PACIFIC NORTHWEST LNG - ADDENDUM TO THE ENVIRONMENTAL IMPACT STATEMENT

Project Description
December 12, 2014

2.0 PROJECT DESCRIPTION

Figure 2-1 Marine Terminal (suspension bridge, trestle and berths)

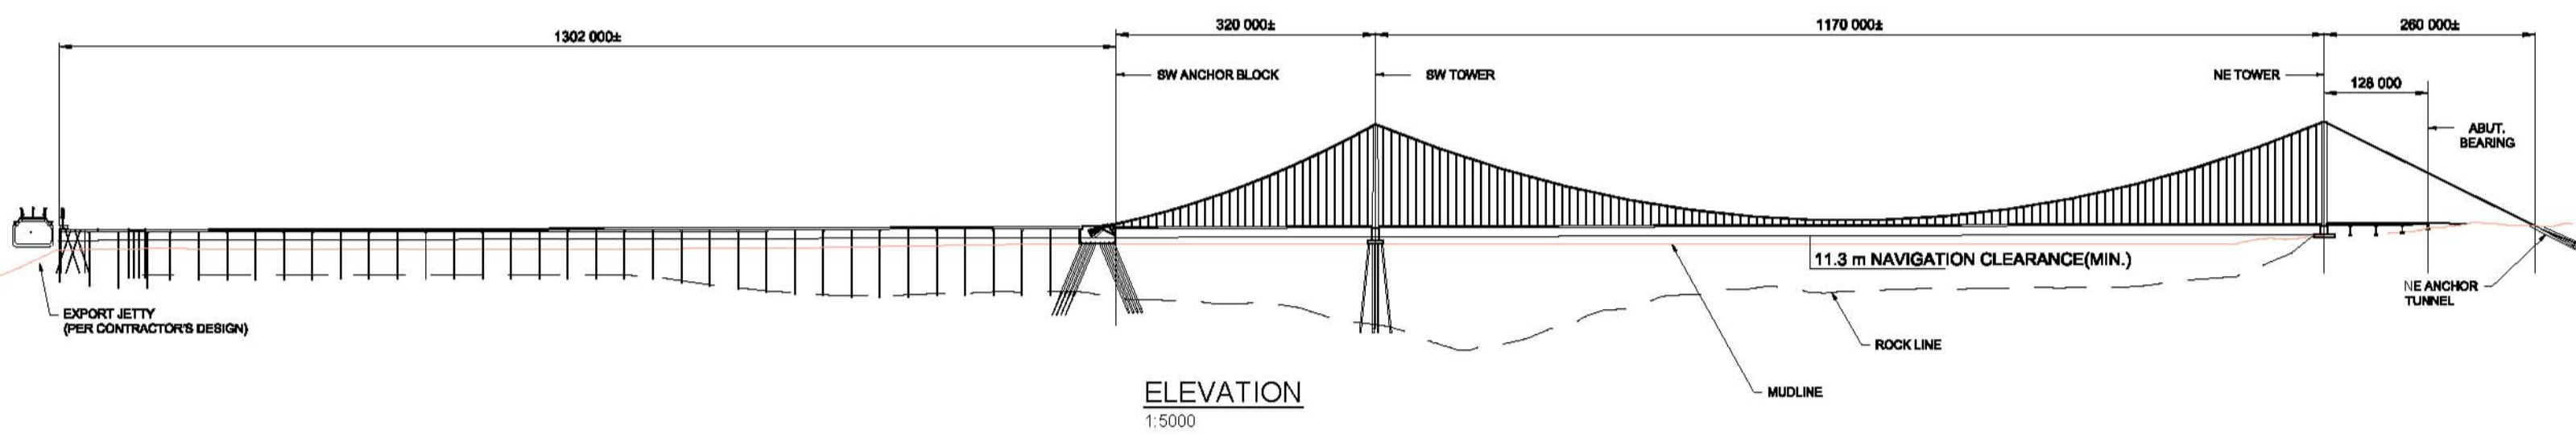
The suspension bridge to support the jetty is 1.6 km in length. It includes a 128 m approach structure from Lelu Island, a 1.2 km suspended span over Flora Bank, and a 320 m suspended span over Agnew Bank (Figure 2-1). The jetty/bridge deck is approximately 24 m wide. The width of the jetty/bridge deck provides space for hanger cables, a vehicle access roadway, two walkway access corridors, LNG pipelines, thermal expansion loops and associated utilities. The bridge deck will be paved; stormwater and fluid spills from vehicles will be directed to a pipe and gutter collection system and pumped back to the LNG Facility for treatment and disposal.

Suspension cables for the northeast tower will be anchored on Lelu Island, 260 m from the tower; the southwest tower will be anchored by a pile supported gravity anchor block 390 m from the tower, on Agnew Bank (Figure 2-1). Lighting on the bridge will include:

The jetty extends from the west end of the suspension bridge and will consist of a 1.1 km conventional pipe pile trestle to the LNG carrier berths (Figure 2-1). The trestle design is similar to the design described in Section 2 of the EIS; it will be approximately 15 m wide with 27 m wide sections at approximately 200 m intervals to allow for pipe expansion loops. The trestle will support the jetty and the marine berths including the field control room, LNG carrier berths, loading arms, and insulated cryogenic piping.

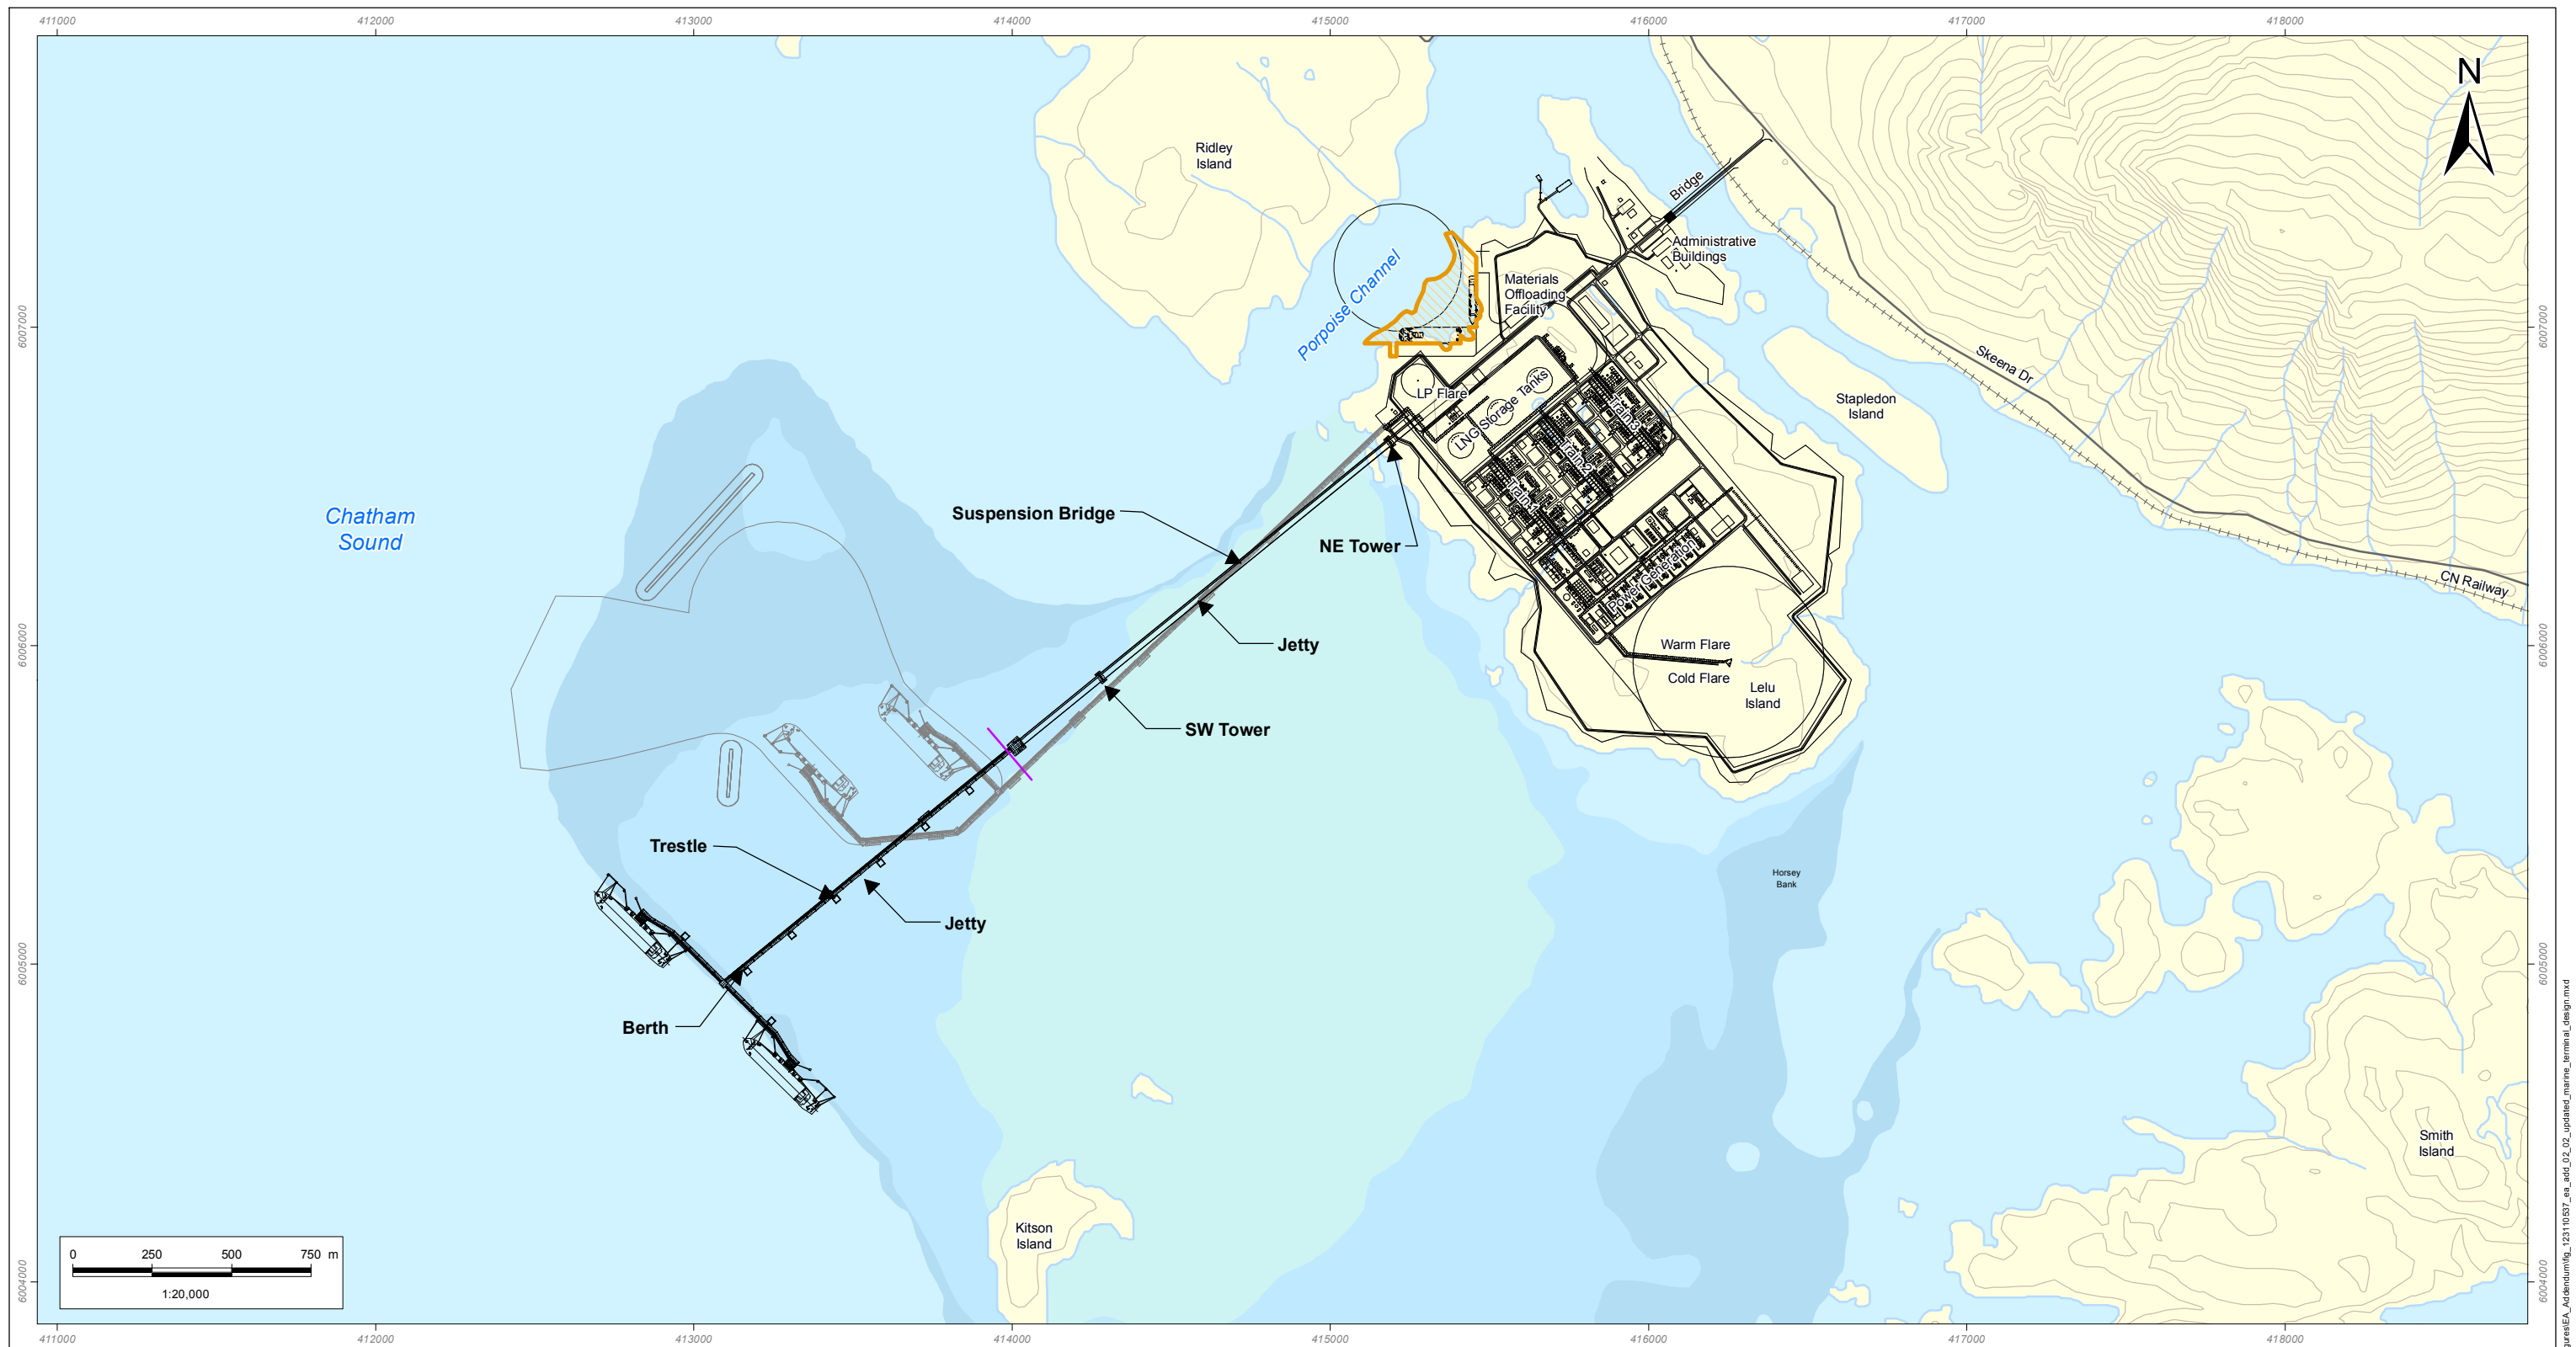
Table 2-3 summarizes the changes to key project components compared to the components described in the EIS. An illustration of the updated marine terminal design (compared to the design submitted as part of the EIS [Option F]) is provided in Figure 2-2.

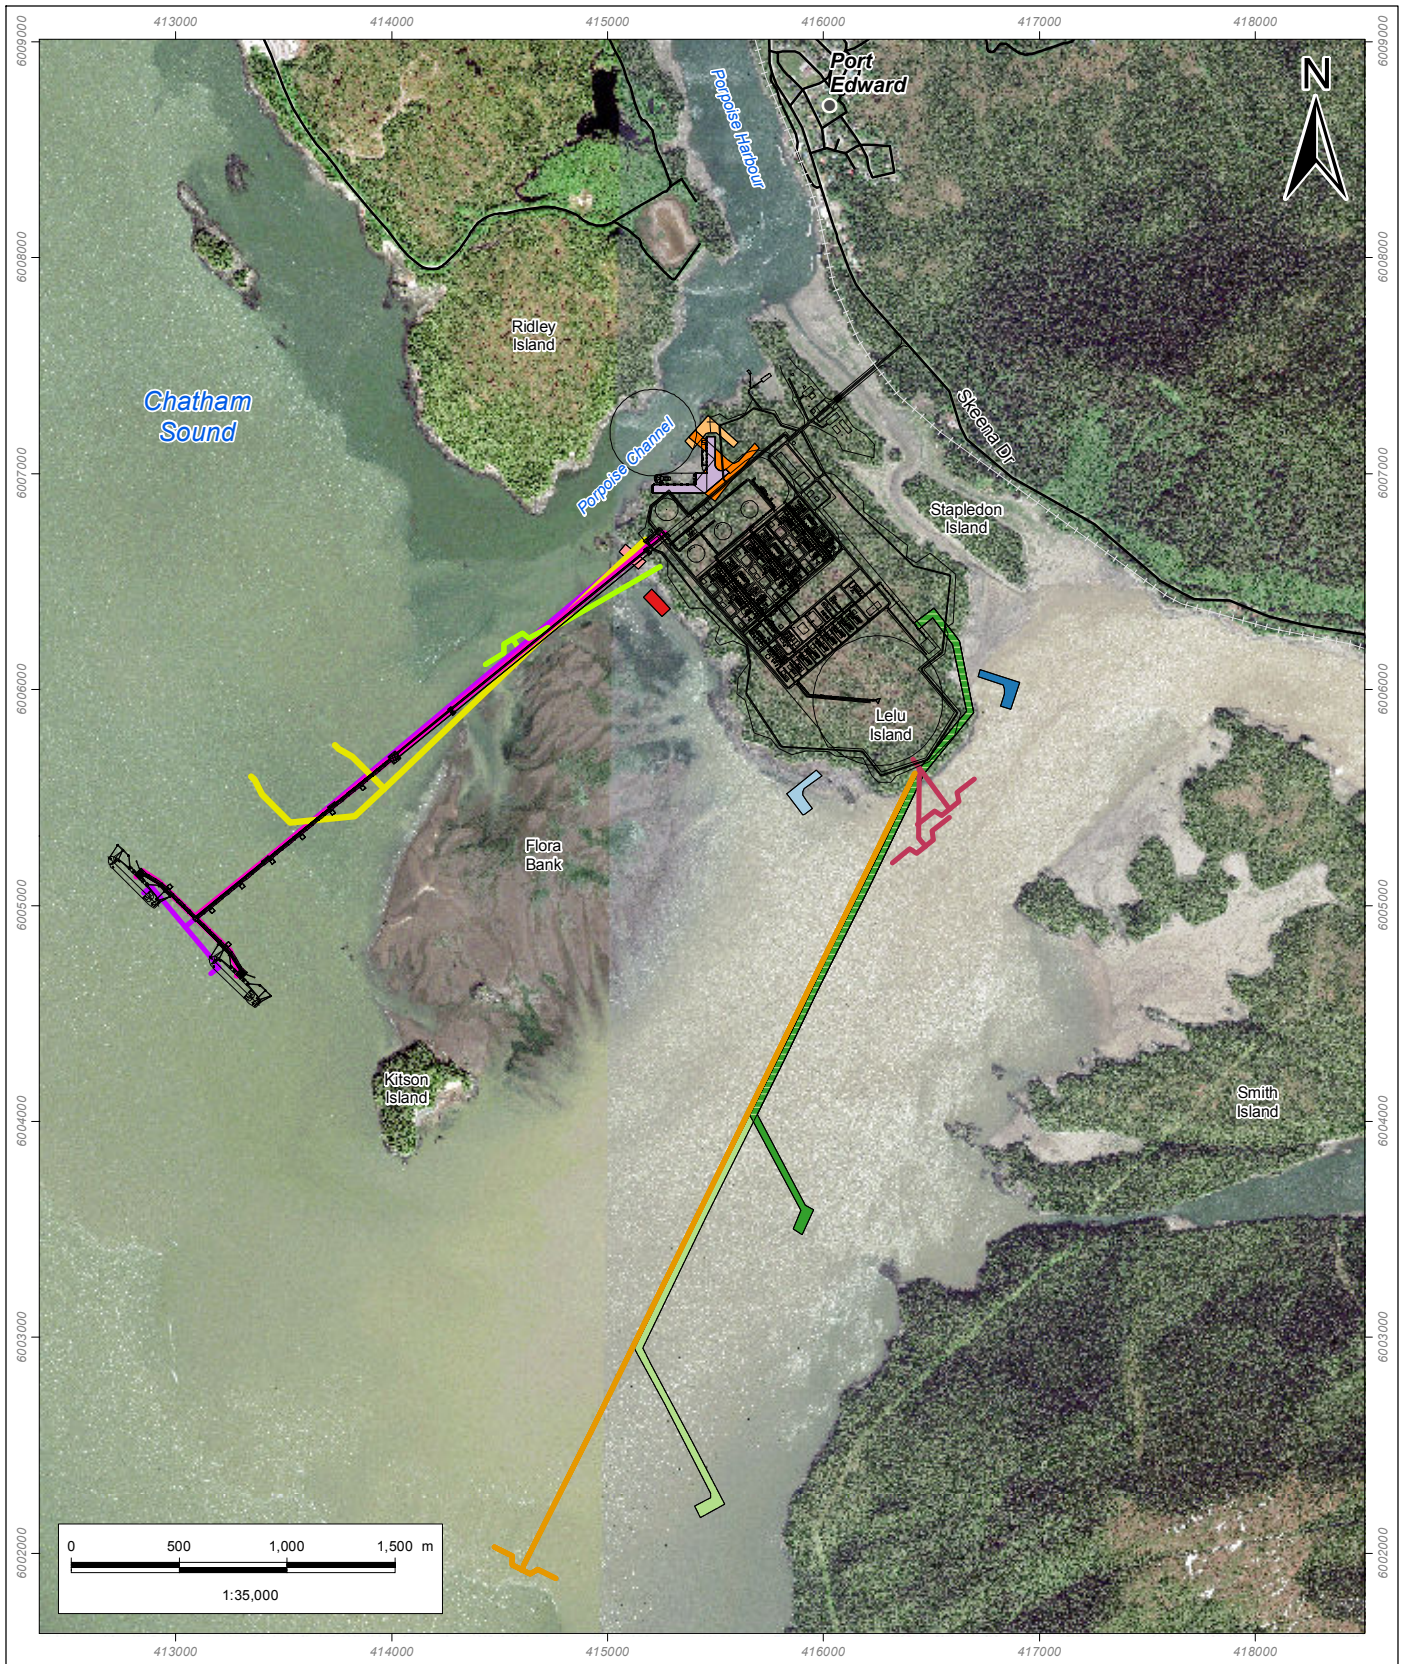
Effects on the Marine Resources VC were considered in the feasibility criteria. Eleven alternatives for placement of the trestles, berths and MOF were considered: five on the south of the Lelu Island and six on the north, along Porpoise Channel (Figure 2-3).

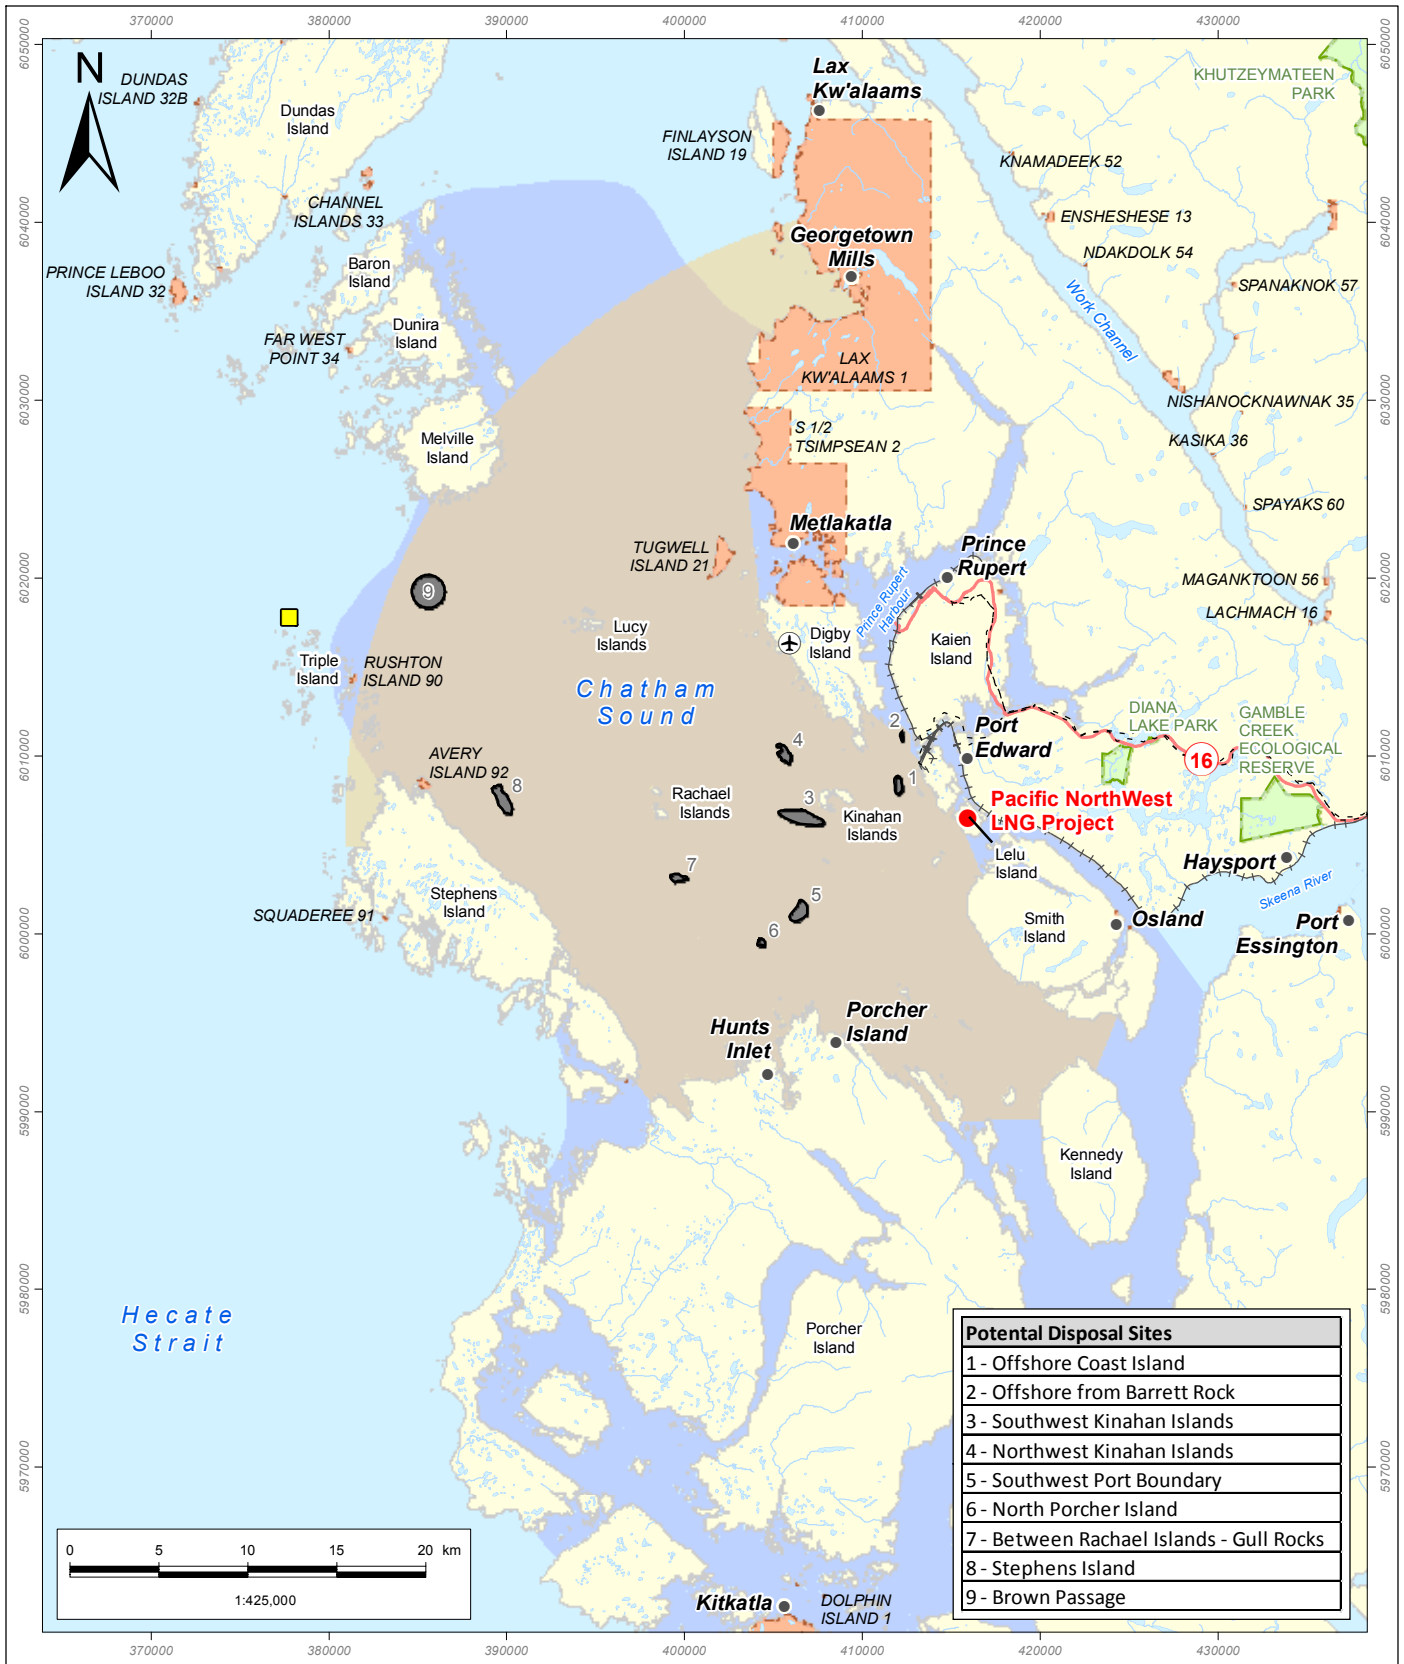
This section and Figure 2-4 respond to the request for Outstanding Information received from the CEA Agency on August 14, 2014.

The Zone of Siting Feasibility used to consider the nine alternative disposal sites is approximately 35 km from Lelu Island (see Figure 2-4).
